COMPLIANCE INSPECTION REPORT

1. Name and address of licensee Uranium Reduction Company 557 First Security Building Salt Lake City, Utah	2. Date of inspection May 12, 1960
	3. Type of inspection Supplementary Follow-up
	4. 10 CFR Part(s) applicable 20 - 40

APPENDIX C

PHOTOGRAPHS

1. Crusher Building showing one of many signs posted as a result of October 26-29, 1959, inspection.
2. Air balance pipe connecting the discharge chute of #1 vibrating screen with the dust collection duct housing below. (See center background)

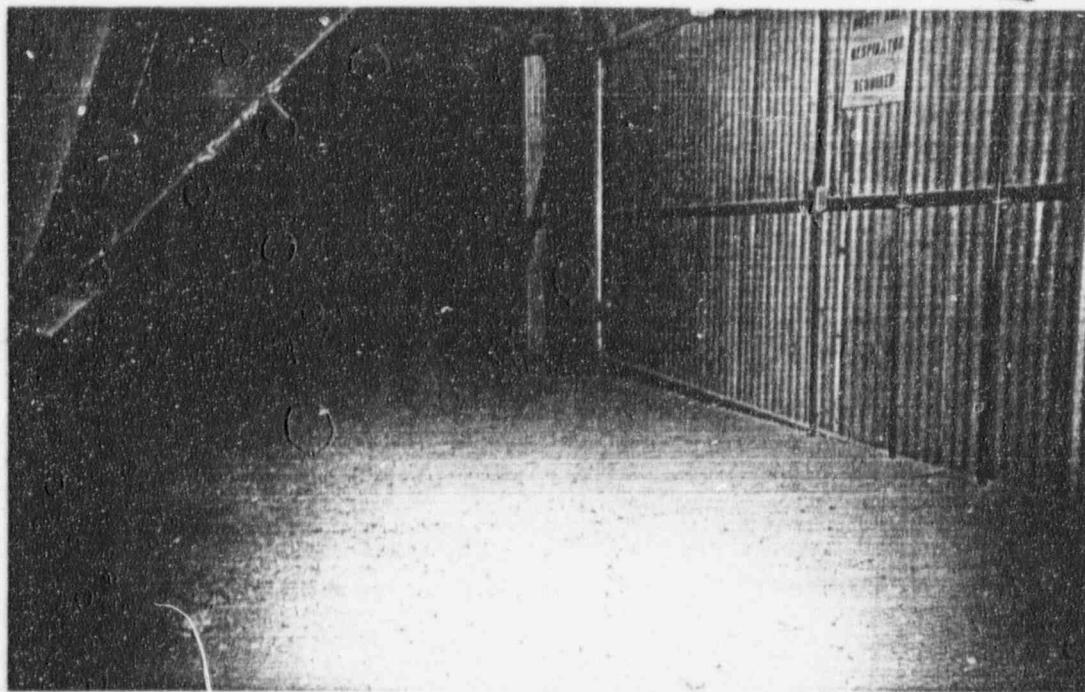
- d. An air balancing pipe has been installed, as proposed, connecting the discharge chute of the primary vibrating screen with the duct housing over the conveyor belt onto which the ore from the screen drops. This serves a purpose similar to that of the pressure equalization ducts located at transfer points on the conveyor belts. The latter were explained fully in the accompanying October inspection report. Careful examination of Photograph 2 shows the air balancing pipe. Although located in a position difficult to photograph, the pipe may be seen above and below the platform in the center background.

3. Area behind #2 and #3 vibrating screens. (Note vacuum cleaner outlet and piping in center of photograph)
4. Centrally located vacuum cleaning plant for crushing area -- Fine ore bin gallery.

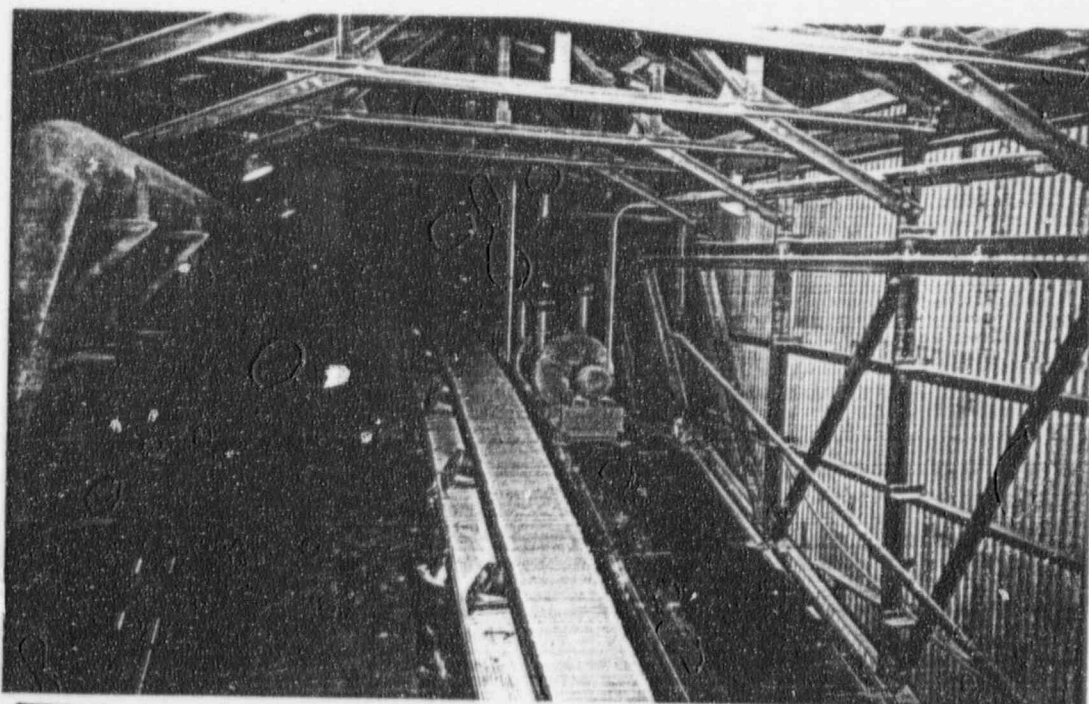
16. While touring the mill with Mr. Izzo, the inspector noted the following:
 - a. The ore deposition in the area of the #2 and #3 vibrating screens, mentioned in the report of the October 26-29, 1959, inspection, was still a problem and a dust generation point (see Photograph 3). (According to Mr. Izzo, however, the cause of the ore falling from the belt had been discovered.

A divider plate which divides the moving ore between the #2 and #3 vibrating screens had been nearly disintegrated by the moving ore. Mr. Izzo explained that replacement of this steel plate was to be made and the problem thereby solved).

- b. The centrally located vacuum cleaning plant for the crushing area has been installed in the fine ore bin gallery, and outlets may be utilized throughout the crushing facility. (Note Photographs 3, 4 and 5).

6. Conveyor belt tension point showing belt cleaner and dust collection ductwork.

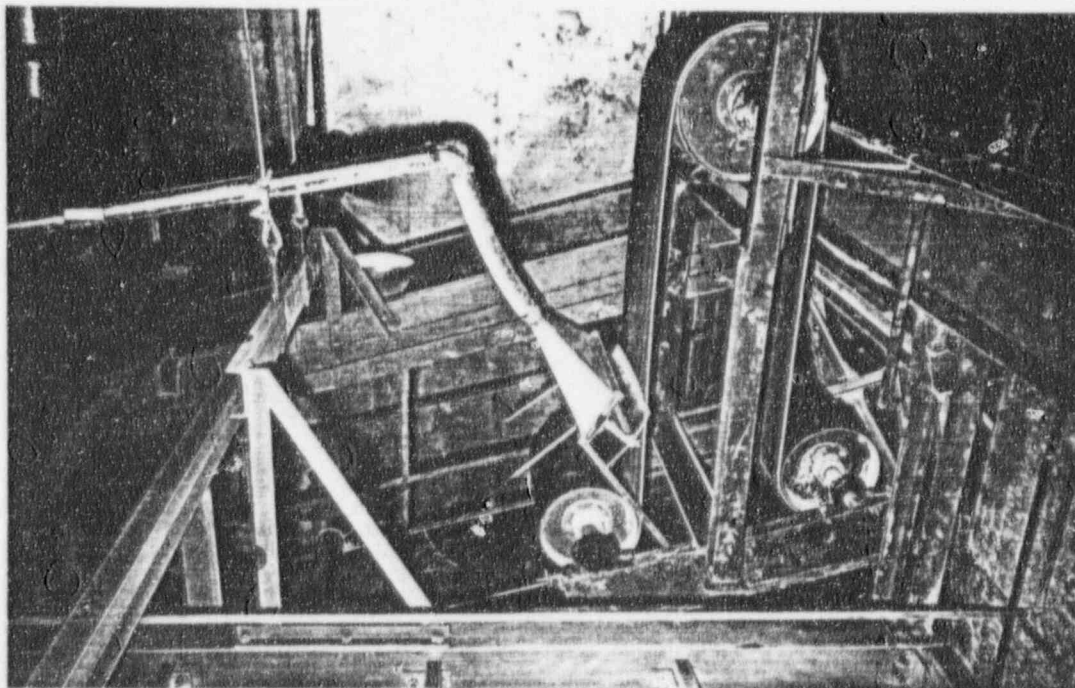
- b. The use of a belt beater and brush, or similar arrangement, to prevent accumulation of dust at the tension points on the conveyor belts has been resolved with an apparatus depicted in Photograph 6. The belt is cleaned of crusted ore by the pliable scraper and the dust thereby generated is vented to the dust collection system via the vent shown in the photograph.

7. Top of yellow cake roaster showing new hood and flues. (Note sign, and tray beneath hearth door)

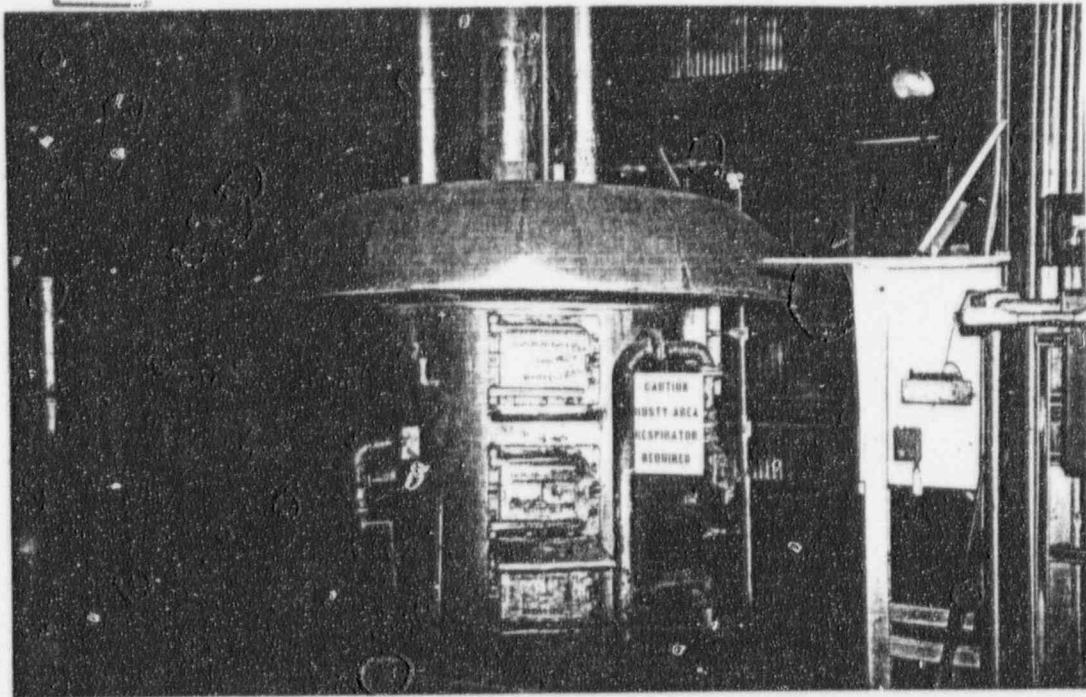
- a. Installation of a vacuum outlet on the hearth drier doors was considered by URC but testing resulted in abandoning the idea in favor of the use of the vacuum and catch tray arrangement (reported in the October 26-29, inspection report), and the newly installed hood over the yellow cake roaster (See Photograph 7).

- d. A recently installed hood over the top of the yellow cake roaster is being utilized along with the catch tray vacuum procedure in lieu of the vacuum outlet installation on the hearth drier doors. The latter did not prove adequate, according to Mr. Izzo. The hood and catch tray apparatus may be seen in Photograph 7.

8. New burner for ashing Shriver Press filter papers.

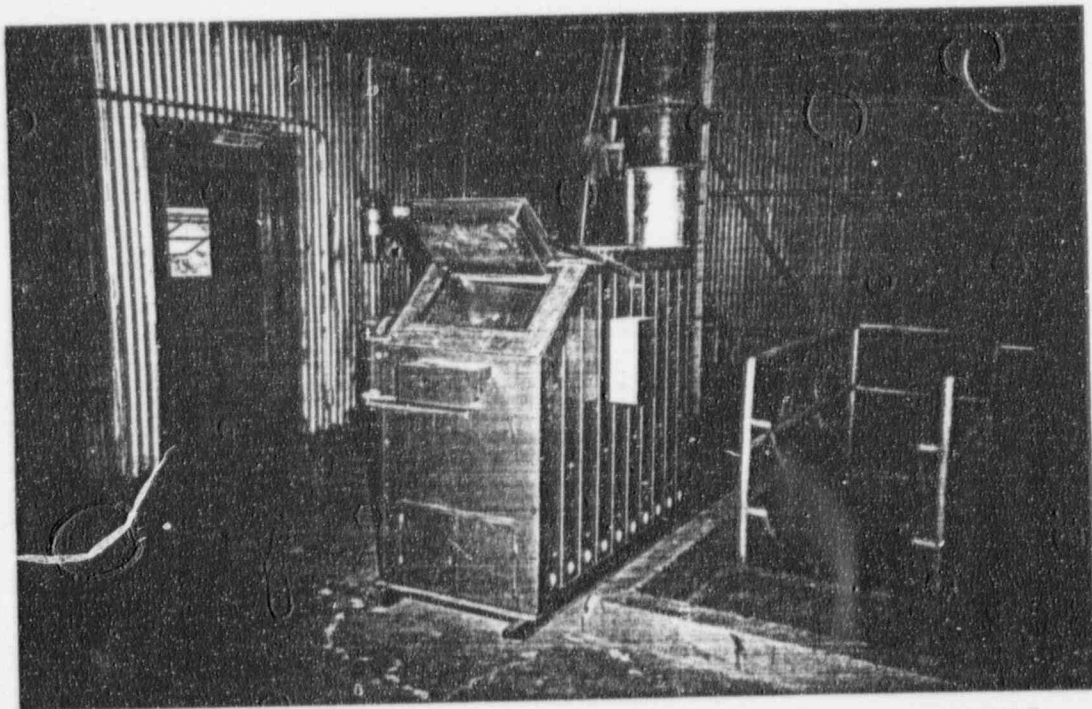
- c. A burner for ashing Shriver Press filters and recovering the yellow cake has been installed near the roaster on the fourth level of the drying area (see Photograph 8). [The burner was not operating at the time of the inspection, but Mr. Izzo assured the inspector that it would be operative in about one week. In the meanwhile, as shown in Photograph 10, the filter papers are stored in an isolated area. The burner will be exhausted through the same flue as the roaster (see Photograph 9).]
